IREDELL COUNTY HEALTH DEPARTMENT

IMPROVEMENT PERMIT / AUTHORIZATION TO CONSTRUCT / OPERATION PERMIT / EXISTING SYSTEM

SITE ADDRESS: 124 Elizabeth Brook Dr. Davidson, NC | PHONE: 704 622-6946 | ALT. PHONE: Sam 704 271-0056

Comments / Conditions: Existing Septic System appears to be Functioning OK at time of inspection. Note: Must follow Iredell Co. Zoning/Building Setbacks

SITE PLAN WORKSHEET

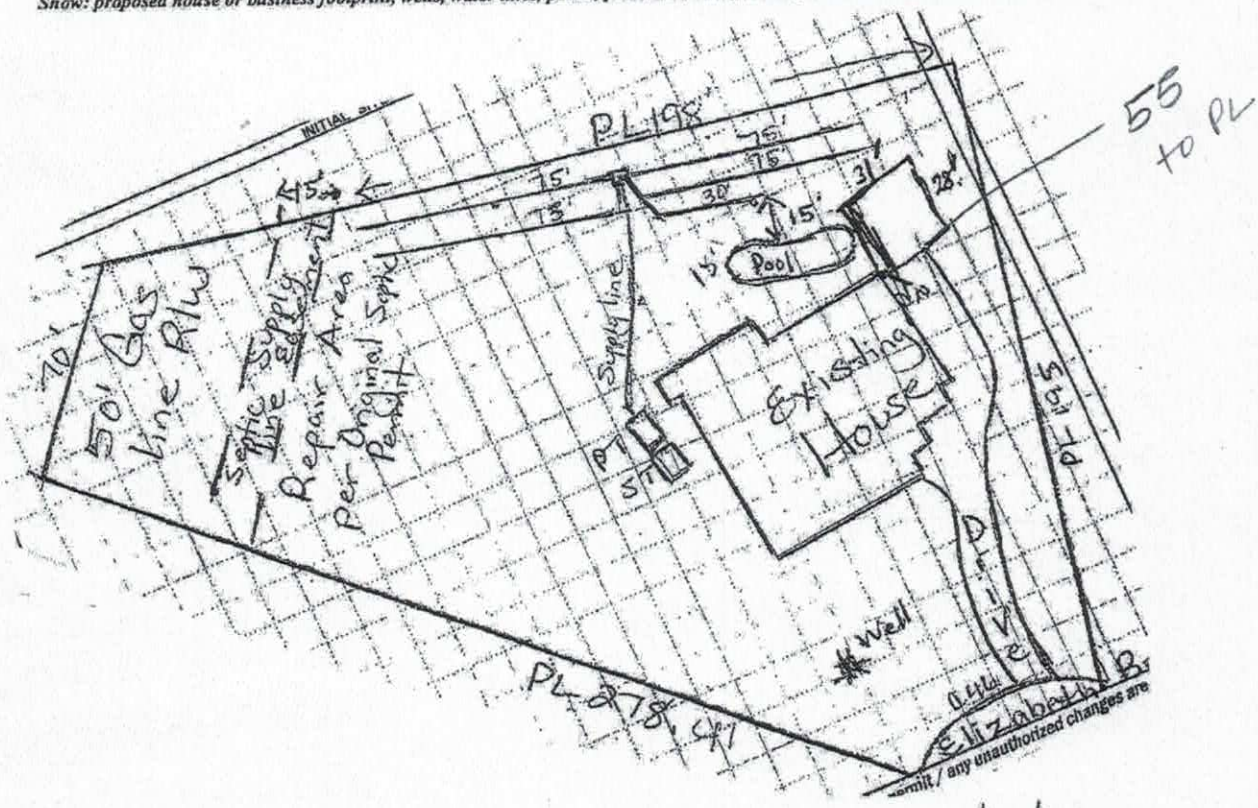
Proposed "Pool House" does not appear to impact Existing Septic System. Any Building drain must be a minimum of 125 Ft (down slope) of Septic System. Any plumbing must be plumbed into main house plumbing.

Pool 20' off Drive
low
Pool house
33' off lowest
Drainline
49' off next
